PLANNING COMMISSON REGULAR MEETING AGENDA

400 Sixth Street	July 6, 2026	7:00 PM
-------------------------	---------------------	----------------

Subject: Market + The Graham/265 E. 2nd Street/Amendment #3; Site Plan Review;
Revised Site Plan and Supplemental Letter Dated June 4, 2026.

Wet Elevation – Approved

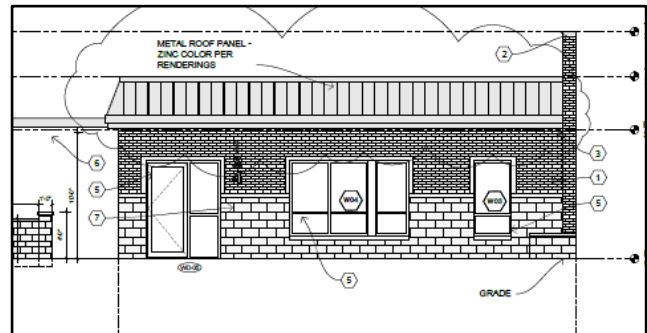
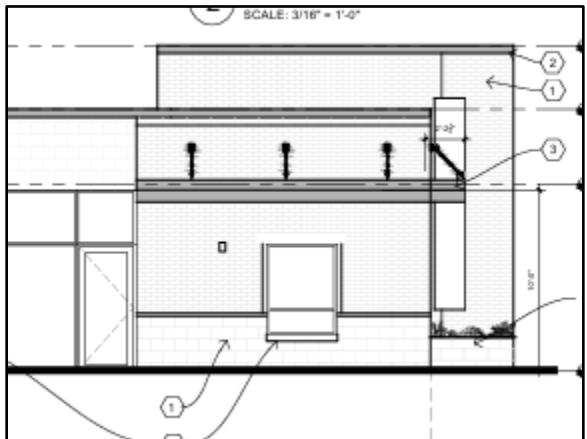
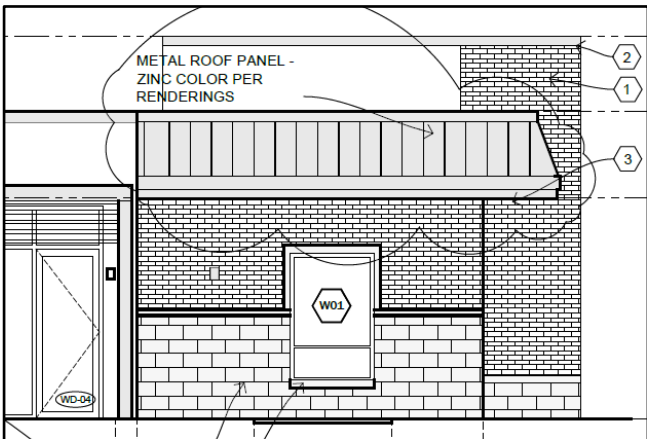
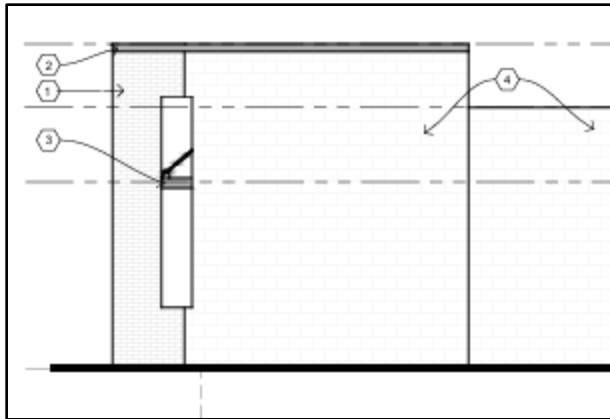
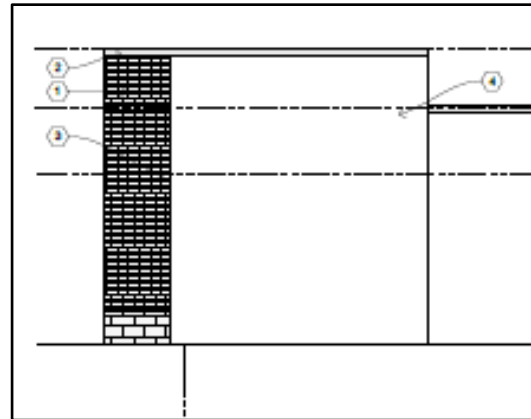
1. **Façade.** The proposed façade changes apply only to the addition, proposing a change from metal paneling to brick as stated above. The zoning ordinance does not provide specific façade or design standards for the I-1 District. Based on the renderings provided, the brick color will be consistent with the proposed color palette for the project, including other shades of red. The proposed material will also be consistent with materials used in the surrounding area.

The change to the proposed building materials/appearance constitutes a major change as defined by Section 2700 (b)(9)(c) and requires Planning Commission approval.
